## Safety Notice

170004

<b>Date:</b>	September 22, 2017
<b>Affected Option:</b>	Operator Protective Alarm (OPA)
<b>Models and Serial Numbers Affected:</b>	See pages 4 to 6
<b>Field Install Kits Affected:</b>	125563 - for all Z-45/25 DC models 1255096 and 1276063 - for machines equipped with ALC500 operating system 1255564 and 1273064 - for machines equipped with ALC1000 operating system.
<b>Subject:</b>	Operator Protective Alarm (OPA) mounting
<b>Allowable Hours:</b>	1 hour

**Illustration 1**

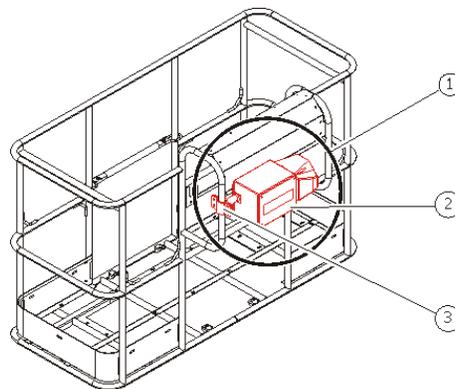
Genie has determined that the Operator's Protective Alarm (OPA) installed on any of the models listed on page 6 is equipped with a mounting bracket that may become loose. **This may cause the OPA assembly to fall off the machine resulting in a collision hazard.**

This Safety Notice requires installing a reinforcement structure around the OPA assembly.

Illustration 4

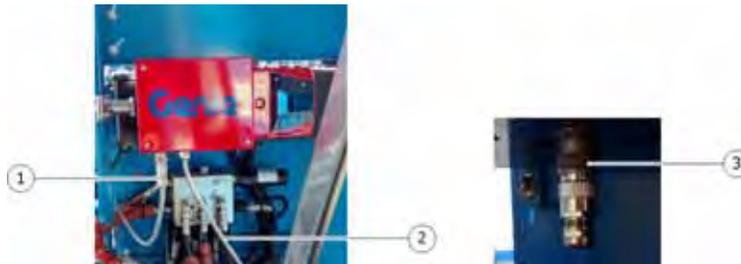
You may continue using the OPA assembly with the machine. However, the OPA assembly must be removed from the machine before transport. Re-install the OPA assembly at the worksite.

- 2 Disconnect harness connector 1 from the red OPA control box. Secure the harness.
- 3 Disconnect harness connector 2 from the platform control box or footswitch. Secure the harness.
- 4 Locate the blanking plug (Genie part number 1255030GT) from the machine document box and plug into the platform or footswitch connector where harness connector 2 was removed.
